POLICY ISSUE
(Notation Vote)

SECY-91-220

Subject: YANKEE ROWE PRESSURE VESSEL EMBRITTLEMENT ISSUES

PROPOSED DECISION UNDER 10 CFR SECTION 2.206

Fig. 16 P(F|E) per reactor year as a function of flaw aspect ratio, for ART values of 285°F and 355°F.

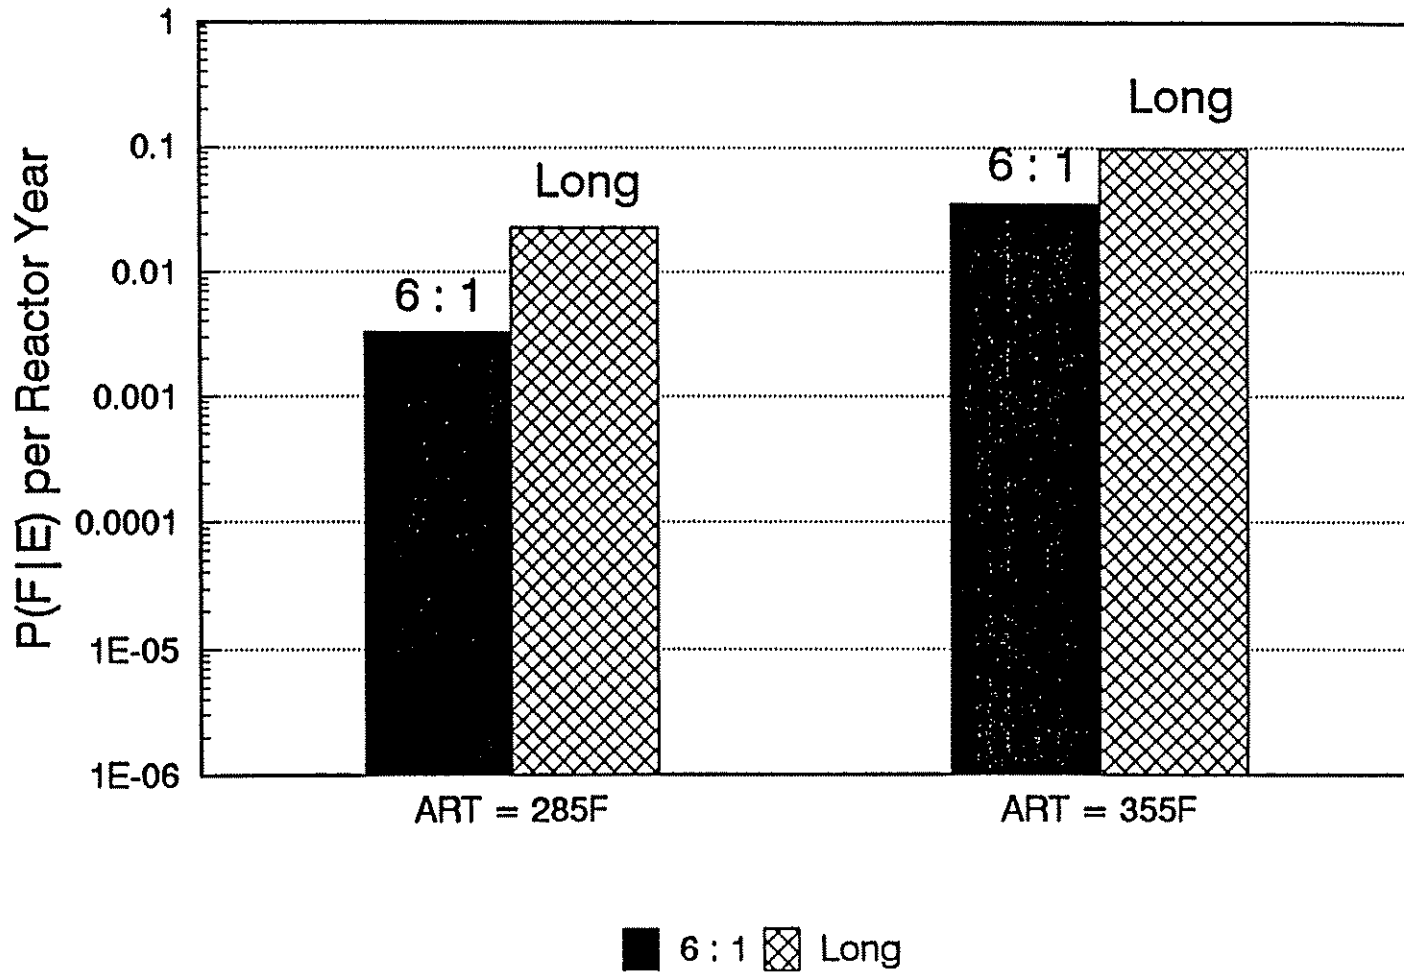
The effect of flaw aspect ratio was also evaluated. The flaw ratios used were the same as those for the welds, specifically a 6:1 ratio and a long flaw assumption. As illustrated in Figure 16, the 6:1 flaw case results in a $P(F|E)$ which is within an order of magnitude below that for the long flaw case.

FIGURE 3 UNIRRADIATED CHARPY DATA FOR
YANKEE SURVEILLANCE PLATE (UPPER SHELL PLATE)
 DEPICTS POSSIBLE VARIANCE IN INITIAL RT_{ndt}

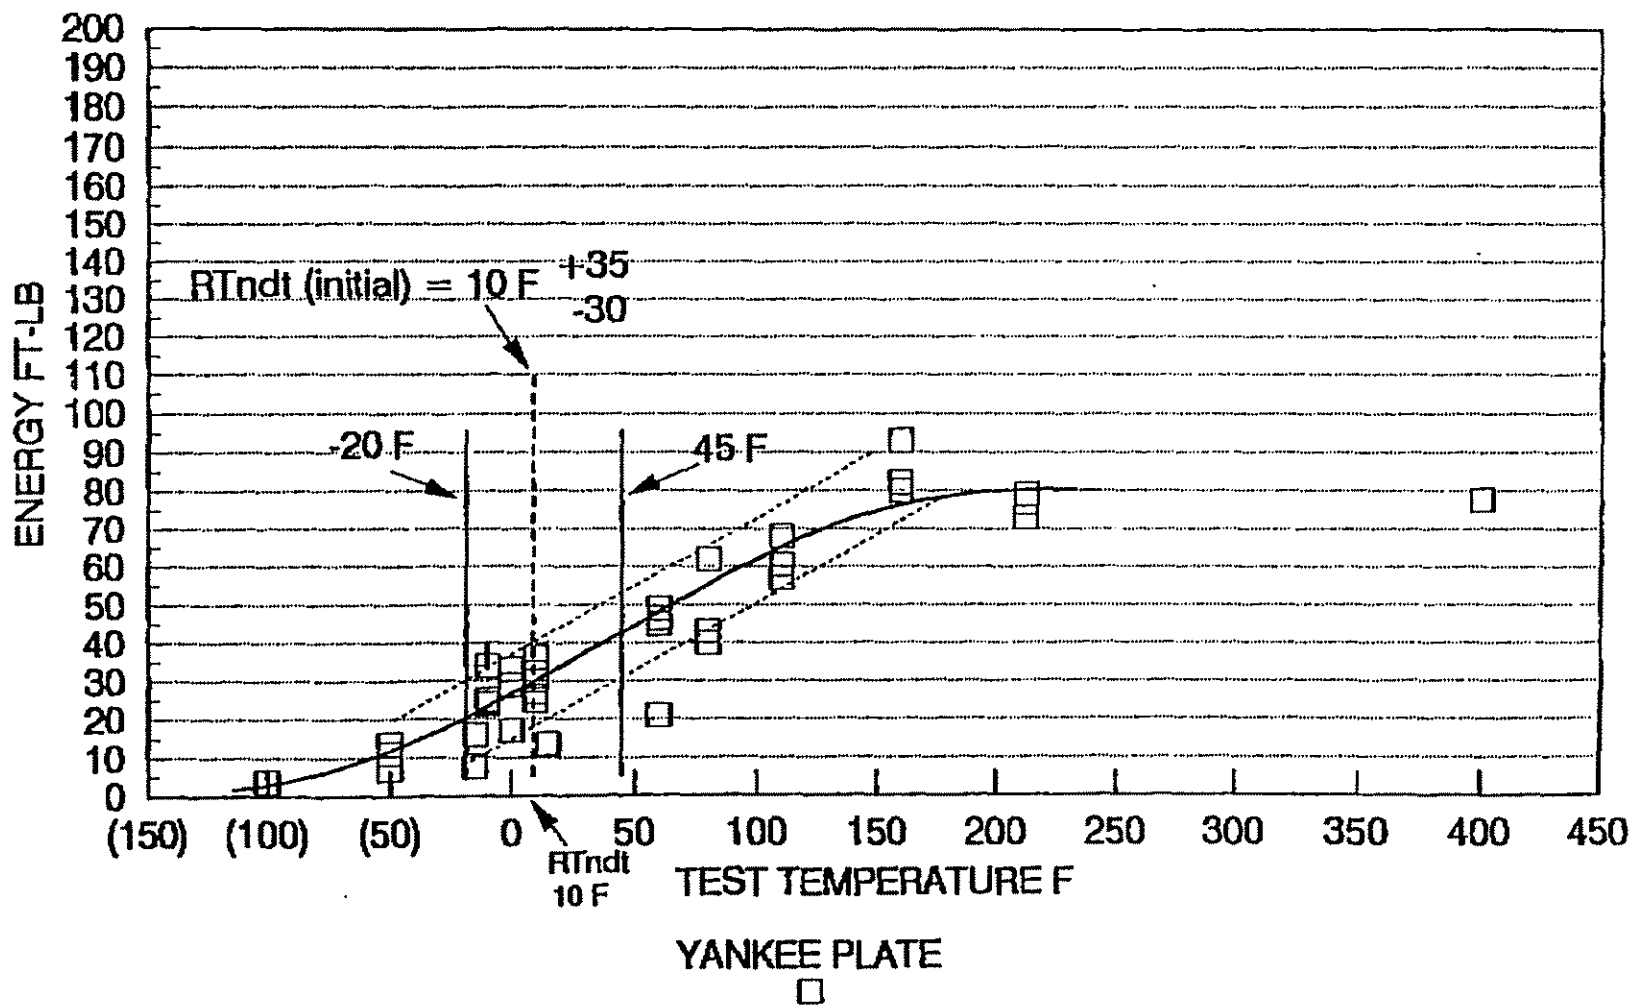
Figure 3 shows the unirradiated data for Yankee surveillance plate. Using the "by eye" technique it is noted that the initial value of RTndt at the 30 ft-lb index is +10F. This value could be as low as -20F or as high as +45F at the 30 ft-lb index (see dotted lines of Figure 3). This means that the uncertainty in RTndt shift value could be 30F at the high end (if the initial value was 30F lower) or the uncertainty could be -35F at the low end.

The last technique used on unirradiated data was the Tanh fit. Using error bands calculated by the "EPRI PLOT" Tanh fit computer routine for data, the variation in RTndt (at the 30 ft-lb index) was calculated to vary plus or minus 10F. The deviation shown in Figure 3 remains conservative.

YANKEE-BR3 SURVEILLANCE DATA
 VERSUS REG. GUIDE 1.99 MARGINS FOR PLATE
 OF 2 SIGMA (PLUS AND MINUS 34 DEGREES F)

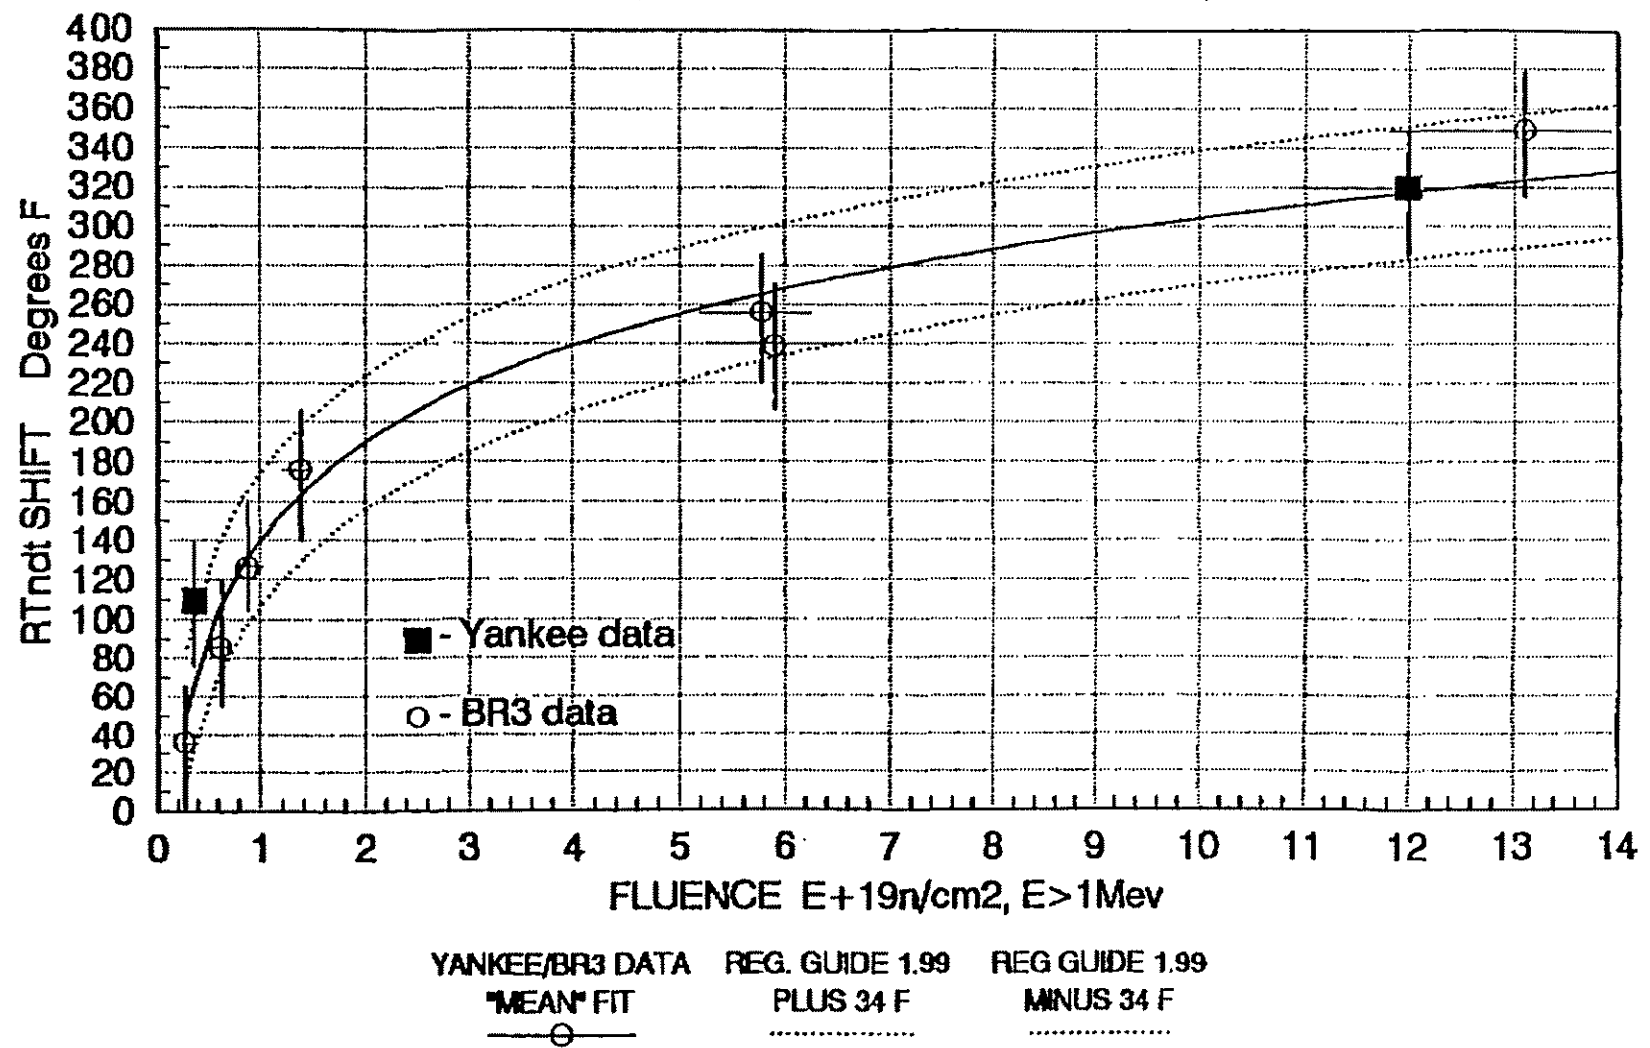
To perform this type of uncertainty analysis for irradiated data is difficult because the amount of Charpy data available for a given irradiation fluence is small. The ASTM Code requires that the Charpy curve be fit through the existing irradiated data. This is shown in Figure 4. One can assume that if many irradiated specimens were tested, the scatter would be similar to that experienced in unirradiated tests. To also apply and add the additional uncertainty band for irradiated data to the uncertainty for unirradiated data would compound the error band to an unrealistic value. ASTM Codes do not require the use of standard deviations for the determination of 30 ft-lb index values. If one were to attempt to calculate such a value however, Yankee shows an uncertainty band for RTndt shift for its data of +30F, -35F. These are the vertical lines of Figure 5.

Figure 5 shows the Yankee and BR3 surveillance data bounded by two dotted lines. These lines represent the margin required to be applied to data by Regulatory Guide 1.99. Figure 5 demonstrates that even with the conservative estimated standard deviations to the Yankee data, Reg. Guide margins bound the data set. In all Yankee PTS calculations, the Reg. Guide 34F margin was added to Yankee estimates of RTndt shift. Thus, the Yankee calculations used bounded (conservative) values of RTndt.
